Ref. Spiegelberg	Ref. BfArM
CMP-202211001	Fall-Nr. 31936/22

## Urgent Field Safety Notice

For Spiegelberg Probes with tunneling:

**“Silverline® Ventricular Probe 8F” (SND13.1.14)**  
**“Silverline® Ventricular Probe 10F” (SND13.1.15)**  
**“True Tunneling Intraventricular Probe 7F” (SND13.1.13TT)**  
**“True Tunneling Intraventricular Probe 9F” (SND13.1.13XLTT)**  
**“Probe 3PN with Trocar” (SND13.1.54)**

Figure 1: left: probeside-connector (1) and securing nut (2); right: finished connection

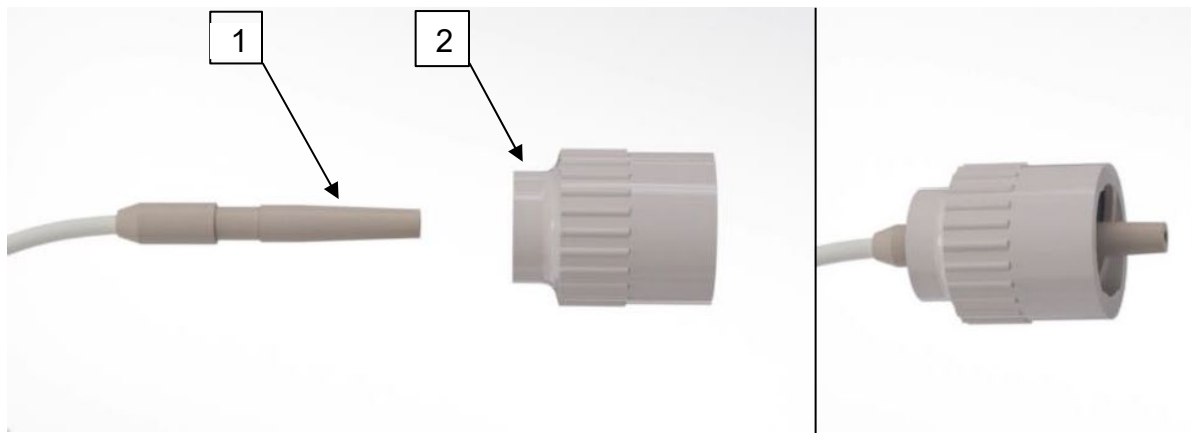
To connect the extension tube, a securing nut (see Figure 1, (2)) is pushed on the probeside-connector (see Figure 1, (1)). The securing nut contains two plates that allow the probeside-connector to snap securely in place inside the securing nut.

Figure 2: Failed connection

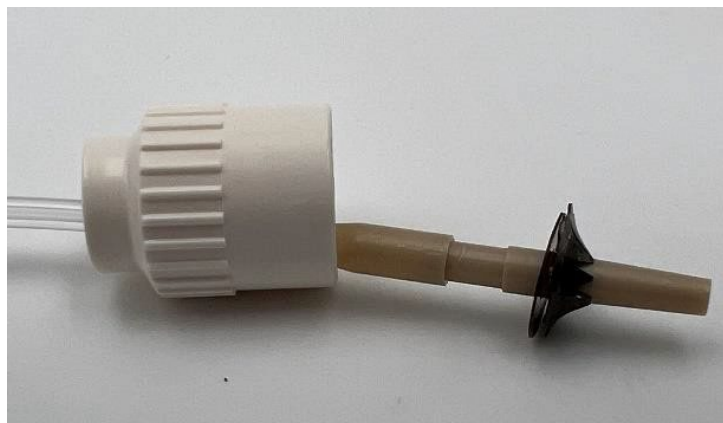
Due to a slowly progressed joining-tool wear, it is possible that the two plates inside the securing nut might break free of the securing nut (see Figure 2).

1. The probe is placed and tunneled. The user tries to make the connection between the securing nut and the probeside-connector. The connection fails (as shown in Figure 2) and cannot be made. The two plates and the securing nut can be removed from the probeside-connector, a new securing nut needs to be used. Therefore, a new product needs to be opened.
2. The probe is placed and tunneled. The user tries to make the connection between the securing nut and the probeside-connector. The connection fails (as shown in Figure 2) and cannot be made. The two plates and securing nut cannot be removed from the probeside-connector, the probe needs to be removed and a new probe must be placed and tunneled.

In order to mitigate the potential risk for the patient, Spiegelberg will provide double packed and sterile security nuts as replacement parts. These security nuts will originate from the updated manufacturing process.
